VOGTLE ELECTRIC GENERATING PLANT  
ADDITIONAL INFORMATION CONCERNING GL 96-06,  
ASSURANCE OF EQUIPMENT OPERABILITY AND CONTAINMENT  
INTEGRITY DURING DESIGN BASIS ACCIDENT CONDITIONS

### Response to GL 96-06 RAI

**FIGURE 1**  
 Accumulator Sample Line Inboard Containment Isolation Valve  
 Tag Numbers 1/2HV-10950, -10951, -10952, -10953  
 Penetrations 72A, 72B, 73A, 73B

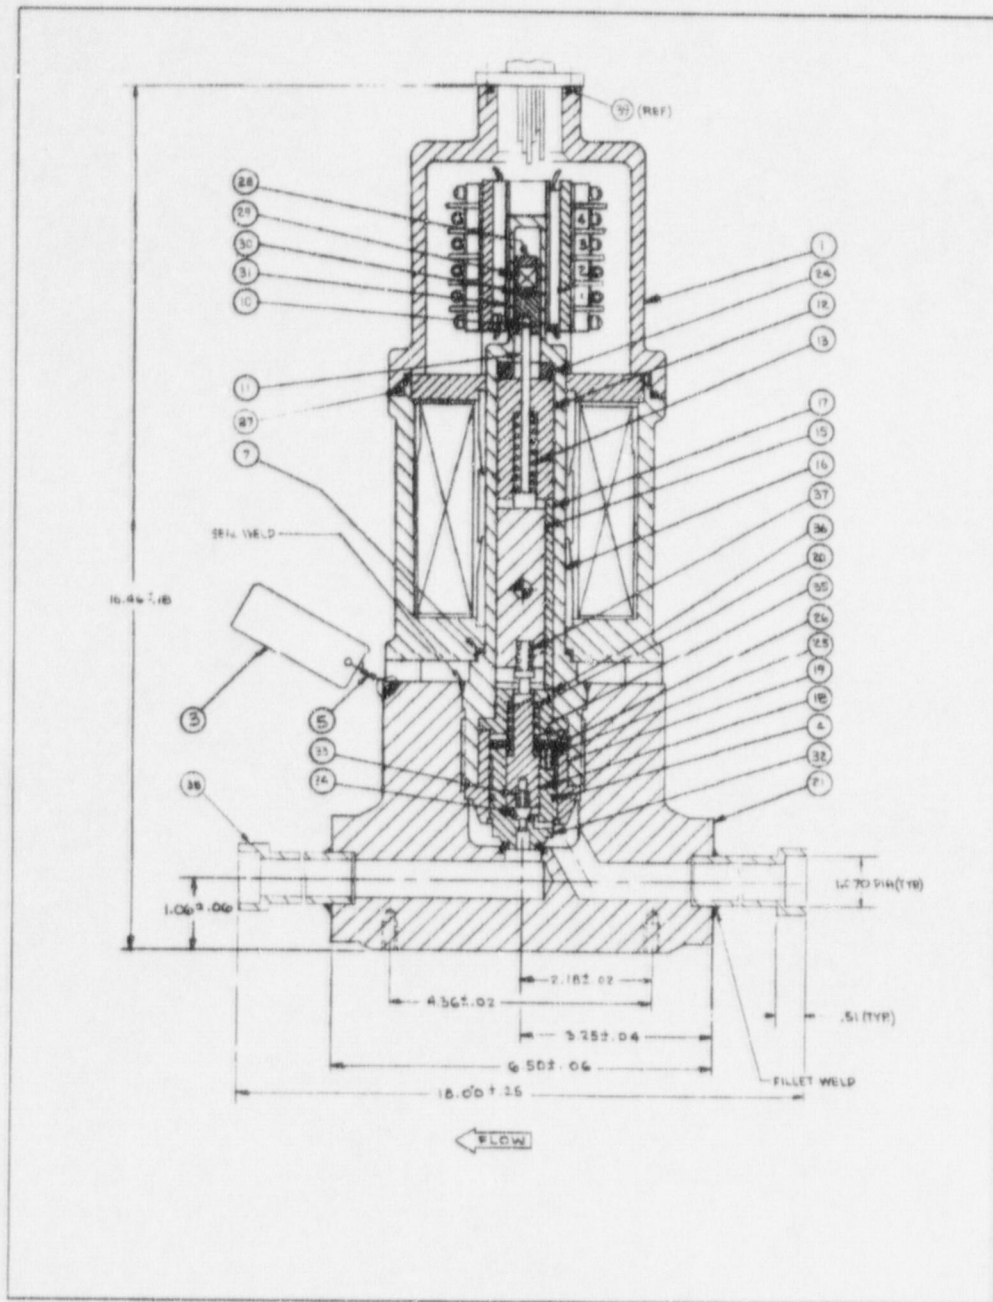
- a. Describe the applicable design criteria for the piping and valves. Include the required load combinations;
- b. Provide a drawing of the valve. Provide the pressure at which the valve was determined to lift off its seat or leak and describe the method used to estimate this pressure. Discuss any sources of uncertainty associated with the estimated lift off or leakage pressure; and
- c. Provide the maximum-calculated stress in the piping based on the estimated lift off or leakage pressure.

The inboard containment isolation valves (tag numbers 1/2HV-10950, -10951, -10952, -10953) are 3/4" normally closed solenoid-operated globe valves with flow over the seat. A drawing of these valves is provided as

Figure 1. The outboard containment isolation valves (tag numbers 1/2-1204-U6-159, -160, -161, -162) are 3/4" normally closed manually operated globe valves.

The normal pressure and temperature for these sections of piping lines is 650 psig and 120 degrees Fahrenheit. An increase in fluid pressure between these valves would act against the underside of the inboard valve's seat. The maximum differential pressure required to lift the valve disc is 121 psid based on a calculation performed by the valve manufacturer. This is based on the worst case condition where spring forces are maximum and the seat diameter is minimum. There are no additional sources of uncertainty associated with this calculated pressure. Opening of the valve would tend to cause a small amount of leakage, which would relieve the expansion of the fluid into the corresponding accumulator (tag numbers 1/2-1204-V6-002, -003, -004, -005). Each of the accumulators are protected from over-pressurization by a relief valve (tag numbers 1/2PSV-8855A, B, C, D), with a setpoint of 700 ( $\pm 21$ ) psig, which is vented to the containment atmosphere. The maximum-calculated stress in the piping is based on a pressure of 842 psig ( $700 + 21 + 121$ ), a pipe outside diameter of 1.050 inches, and a pipe wall thickness of 0.113 inches; along with the required loading combinations. The calculated stress for these conditions is 33,198 psi. This value is less than the allowable stress of 36,720 psi at ASME Section III faulted conditions.
